Application No. : 10/762,291
Art Unit : 3746

Amendments to the Drawings:

REMARKS

Fig. 2

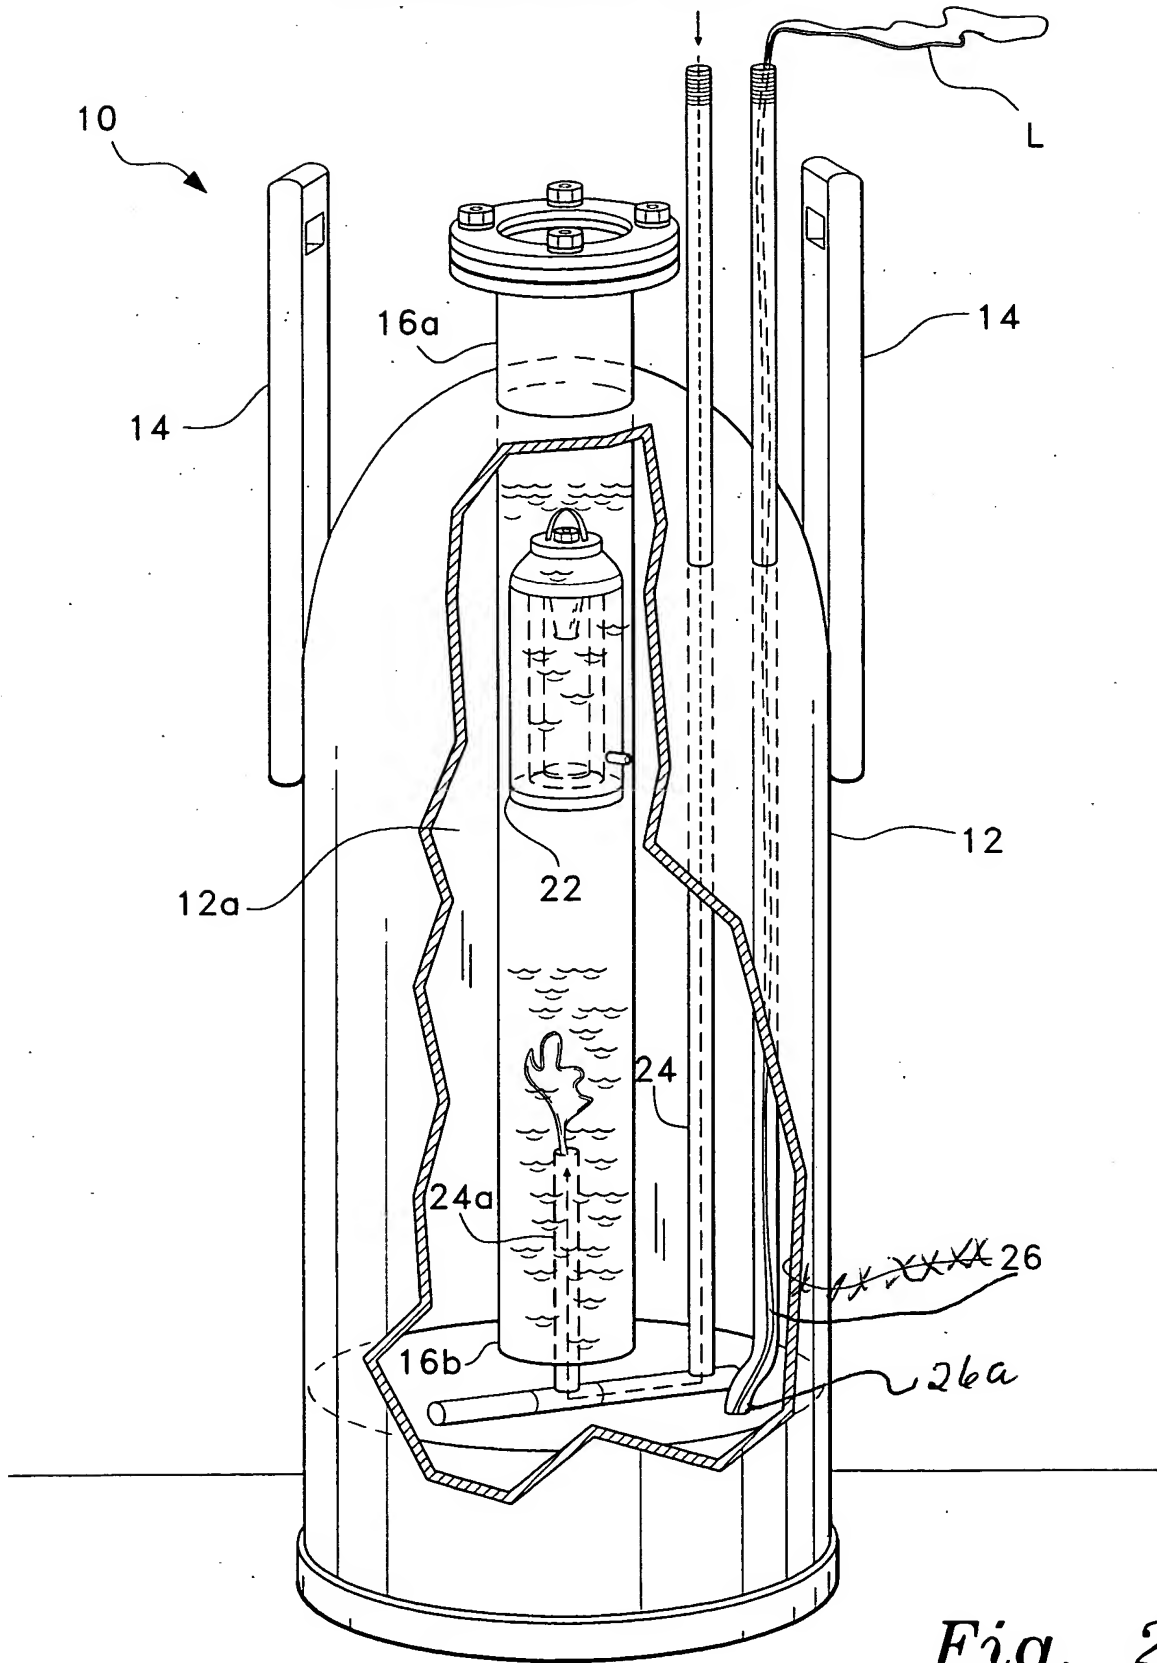
A proposed drawing change is submitted herewith. Proposed changes are shown in red. The attached sheet of drawings includes changes to Fig. 2. This sheet, which includes only Fig. 2, replaces the original sheet including only Fig. 2. In Fig. 2, the lead line from reference character 26 has been corrected to point to the liquid discharge pipe. Reference character 26a has been added to specifically show the opening in liquid discharge pipe 26.

Applicant has amended the drawings to correct the designation of lead line 26. The drawings have also been amended to designate the opening from line 26 into chamber 12a. The opening is shown at 26a. The specification at page 5 has been amended to recite opening 26a. No new matter has been added. The specification and claims have also been amended to correct the punctuation and grammatical errors as suggested by the Examiner. Claims 3 and 12 have been amended to provide proper antecedent basis for the structure recited therein.
